EVALUATION OF SIGNIFICANT HAZARDS CONSIDERATIONS FOR PROPOSED CHANGES TO APPENDIX A TECHNICAL SPECIFICATIONS OF FACILITY OPERATING LICENSES NPF-72 AND NPF-77

Commonwealth Edison (ComEd) proposes to revise Figure 3.4-4a, "Nominal PORV Pressure Relief Setpoint Versus RCS Temperature For The Cold Overpressure Protection System Applicable up to 5.37 EFPY (Unit 1)," of Technical Specification (TS) 3.4.9.3. The index page entry associated with Figure 3.4-4a will also be changed to reflect the changes in Figure 3.4-4a. The format of Figure 3.4-4a will be revised to improve readability. Figure 3.4-4a describes the nominal Pressurizer Power Operated Relief Valve (PORV) setpoints for the Low Temperature Overpressure Protection System (LTOPS) as a function of Reactor Coolant System (RCS) temperature.

The current Figure 3.4-4a, "Nominal PORV Pressure Relief Setpoint Versus RCS Temperature For The Cold Overpressure Protection System Applicable up to 5.37 EFPY (Unit 1)," will be replaced with a new Figure 3.4-4a, "Nominal PORV Pressure Relief Setpoint Versus RCS Temperature For The Cold Overpressure Protection System Applicable up to 16 EFPY (Unit 1)."

FIGURE 3.4-4a
NOMINAL PORV PRESSURE RELIEF SETPOINT VERSUS
RCS TEMPERATURE FOR THE COLD OVERPRESSURE PROTECTION SYSTEM
APPLICABLE UP TO 5.37 EFY (UNIT 1)

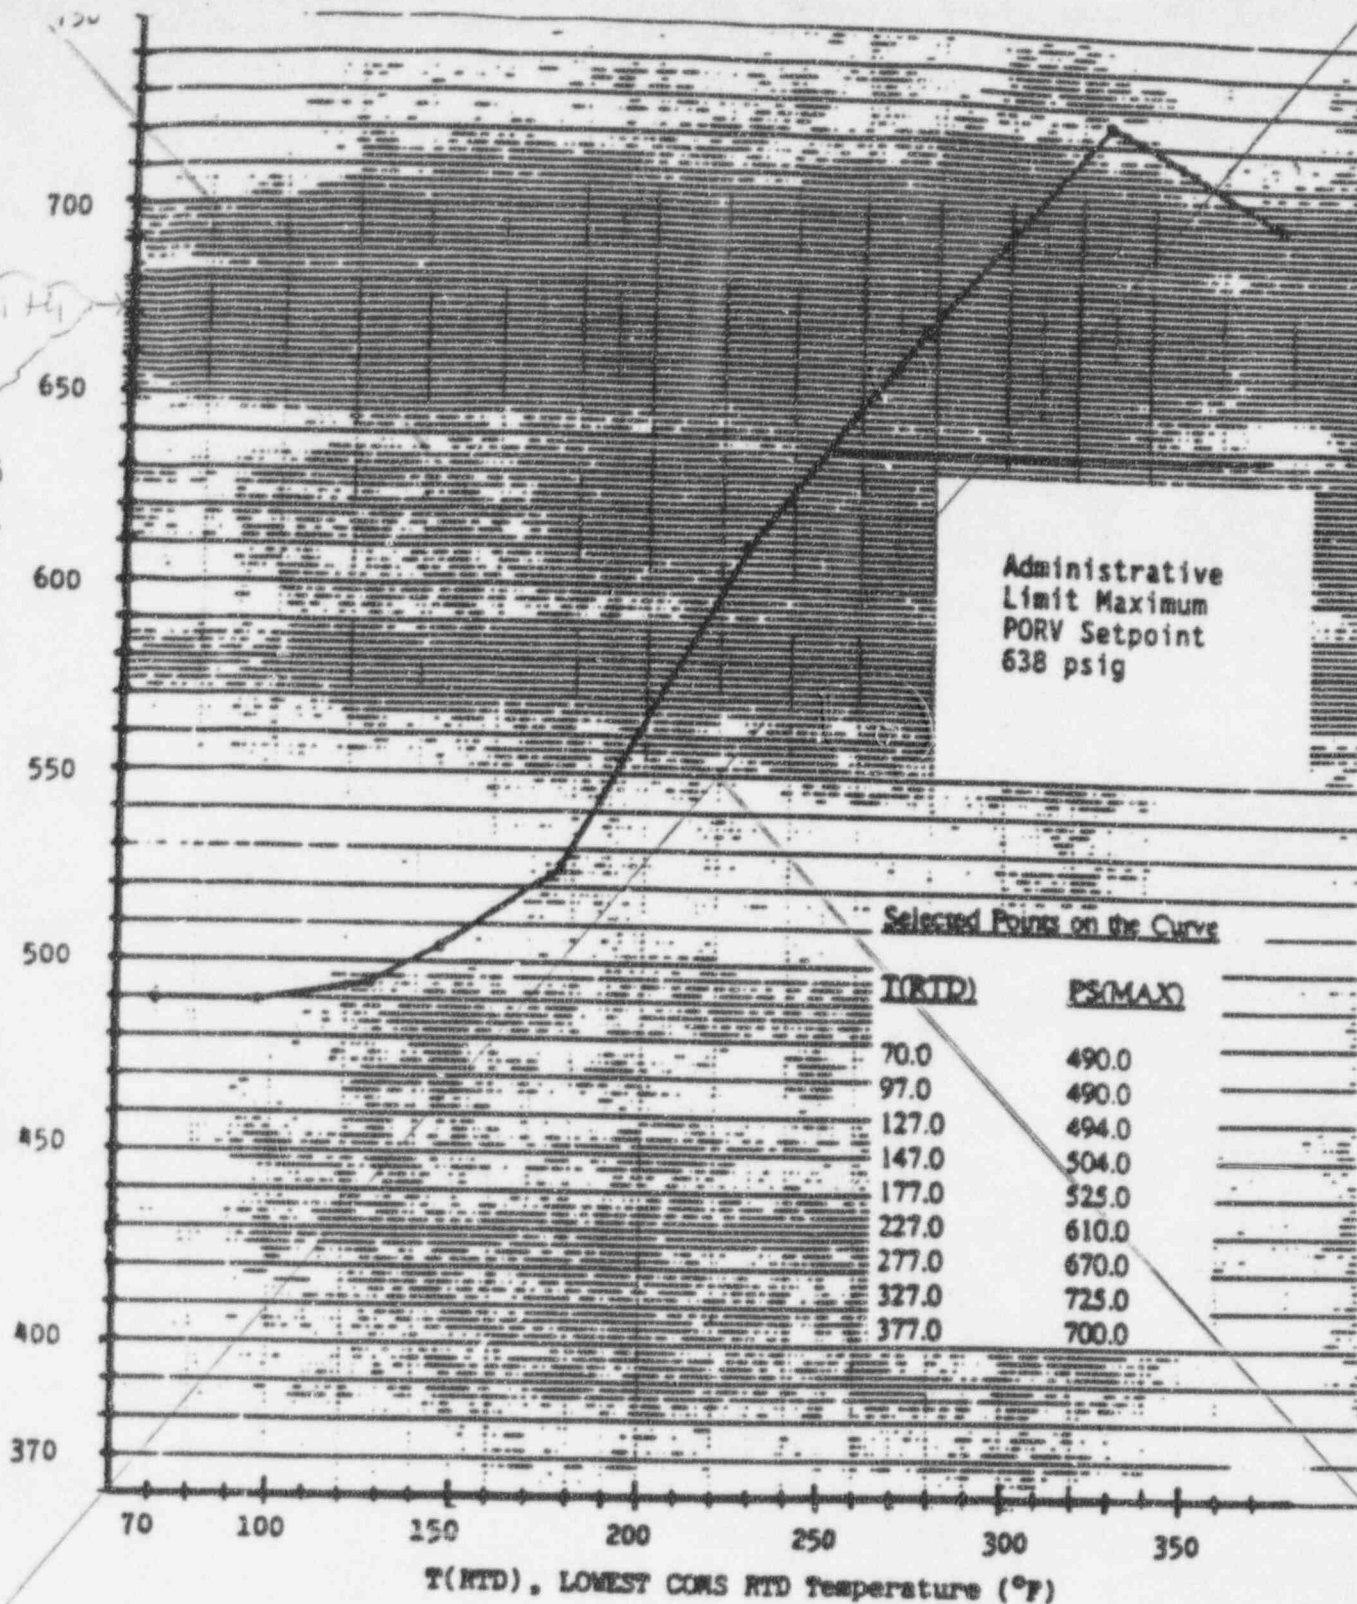
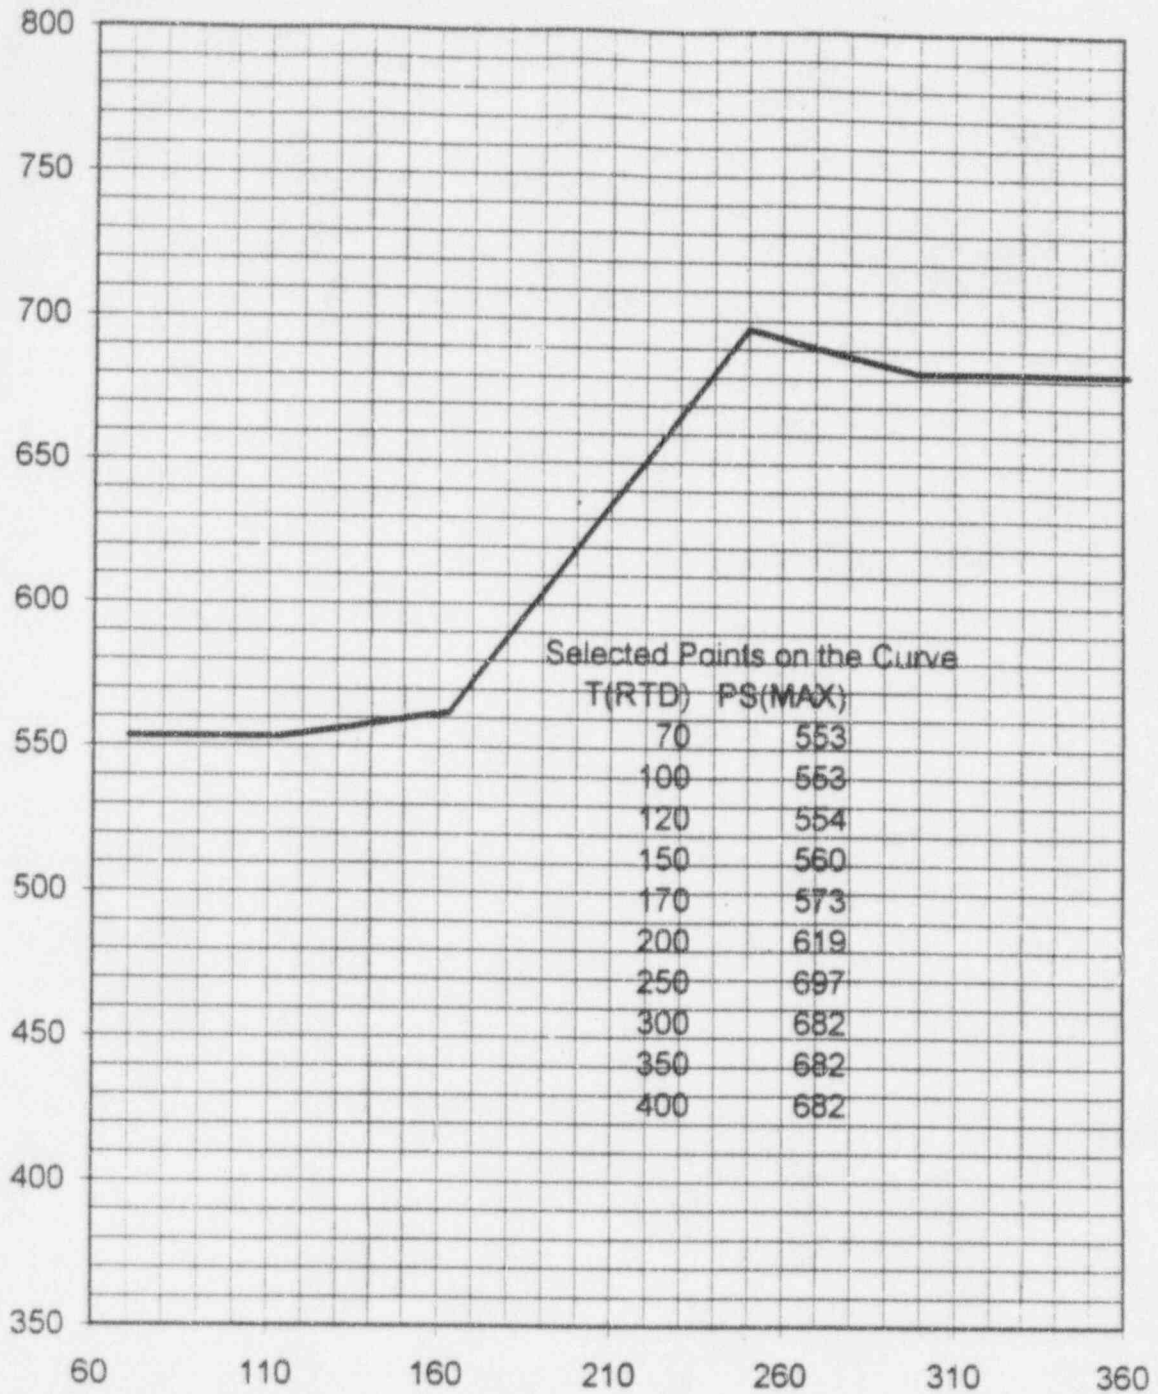
Replace with
Insert A

Currently, Figure 3.4-4a is valid until Braidwood Unit 1 reaches 5.37 Effective Full Power Years (EFPY). In addition, the current Figure 3.4-4a contains an administrative limit line at 638 pounds per square inch gauge (psig) to protect PORV downstream piping from water hammer effects during pressurizer solid water conditions and contains allowances for a 60 psig pressure instrument uncertainty, a 13°F temperature instrument uncertainty and a 14°F temperature streaming allowance.

The current Figure 3.4-4a also contains allowances for a 50°F thermal transport effect associated with the postulated heat injection transient.

In order to extend the duration of applicability for Figure 3.4-4a to 16 EFPY and remove the administrative limit line it is necessary to revise the current Figure 3.4-4a.

Finally, a constant 800 psig RCS pressure value was selected to control PORV piping loads due to waterhammer effects from PORV actuation during water solid pressurizer conditions. The pressure values on the revised 10 CFR 50 Appendix G PT limit curve, or the 800 psig PORV discharge piping water hammer load limit, whichever was lower at a given temperature, were then used to develop the revised Figure 3.4-4a.

That portion of the revised Figure 3.4-4a limited by the Appendix G PT limits retains the 60 psig pressure instrument uncertainty, the 13°F temperature instrument uncertainty and the 50°F thermal transport effect for heat injection events.

For that portion of the revised Figure 3.4-4a limited by the 800 psig PORV discharge piping limit, the 60 psig pressure instrument uncertainty is retained with credit taken for the elevational difference between the PORV LTOPS pressure sensor and the PORV itself. This elevation difference is approximately 74 feet, so the actual pressure at the PORV discharge will be approximately 32 psig less than the pressure seen by the pressure transmitter. The 13°F temperature instrument uncertainty and the 50°F thermal transport effect for heat injection events are also retained in this section of Figure 3.4-4a.

The 14°F temperature streaming allowance is not included in the LTOPS setpoint curve since WCAP 14040, "Methodology used to Develop Cold Overpressure Mitigating System Setpoints and RCS Heatup and Cooldown Limit Curves," Section 3.2.2, "Pressure limit Selection," assumes LTOPS events are most likely to occur during isothermal conditions in the RCS. Thus, temperature streaming would not be a consideration.

The revised Figure 3.4-4a also does not contain the administrative limit line at 638 psig.

Figure 1
Braidwood Unit 1 Appendix G
and
Code Case N-514 Limits at 16 EFPY

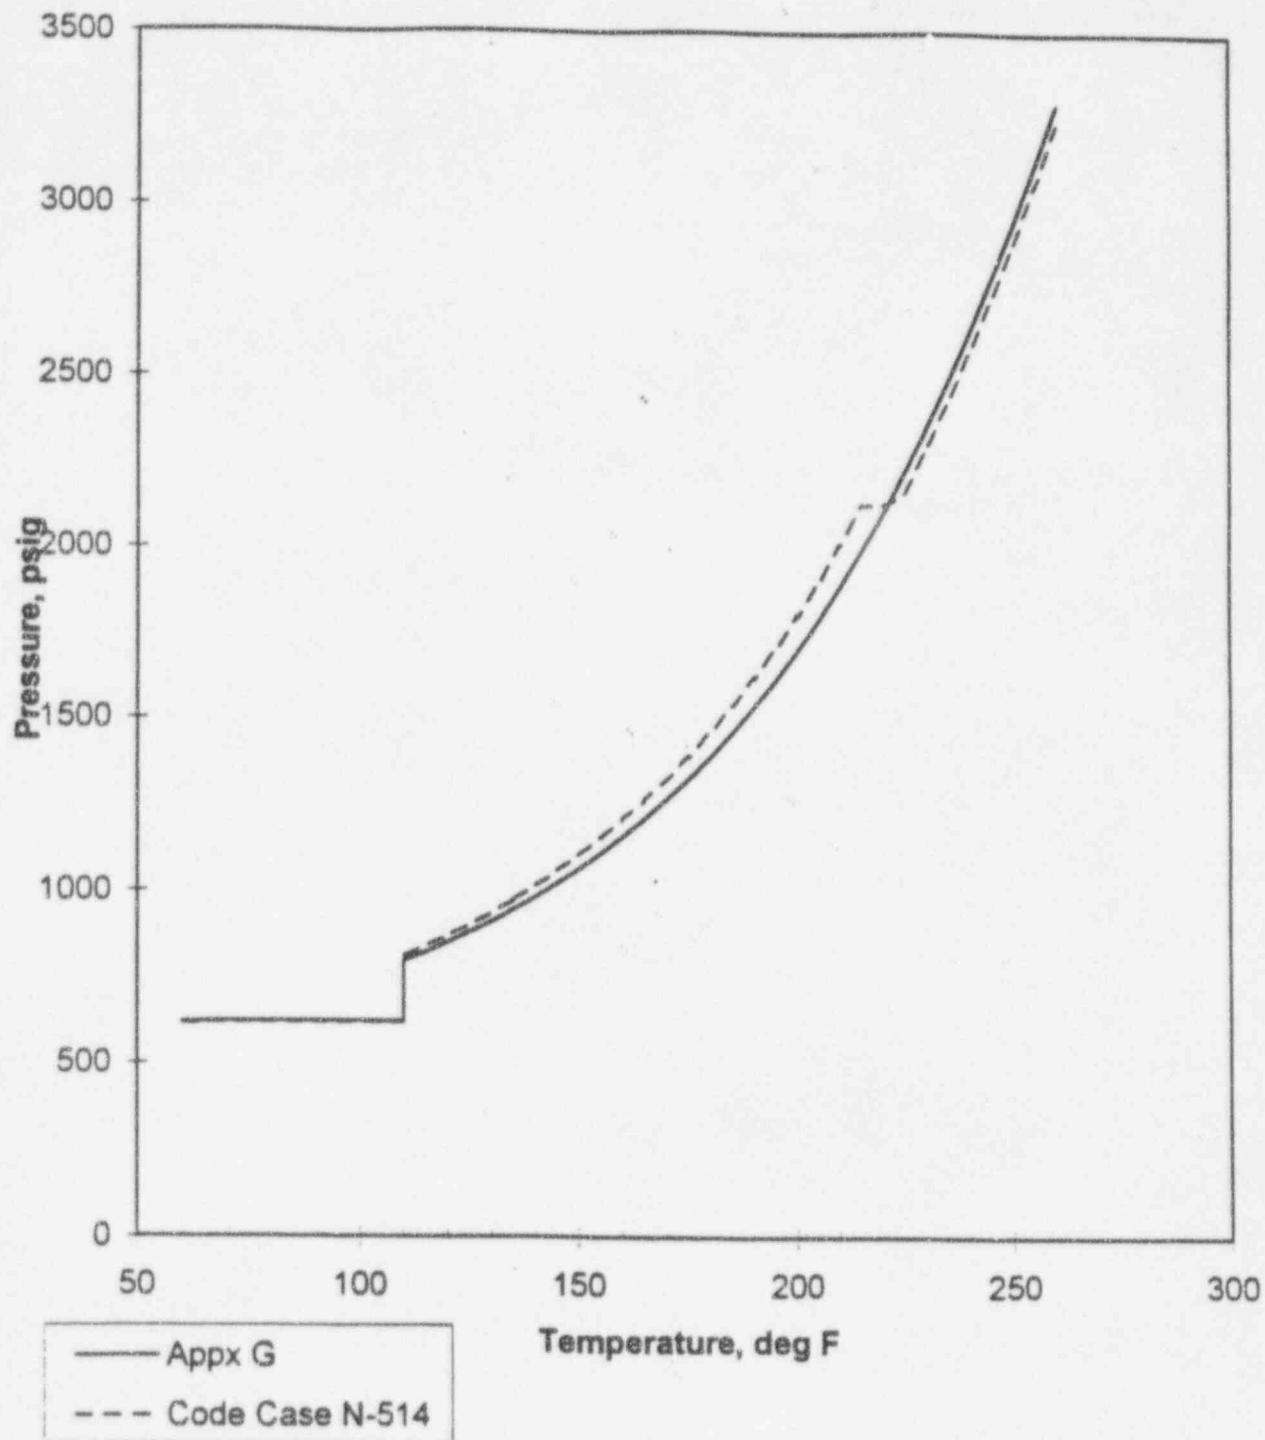
1. Provide the revised Appendix G curves based on 8.5 effective full power years (EFPY) for the reactor heatup and cooldown process.

2. Provide the curves of pressure/temperature (P/T) limits which are developed in accordance with ASME Code Case N-514.

See Figures 1 and 2 and Table 1 of this attachment.

See Figures 1 and 2 and Table 1 of this attachment.
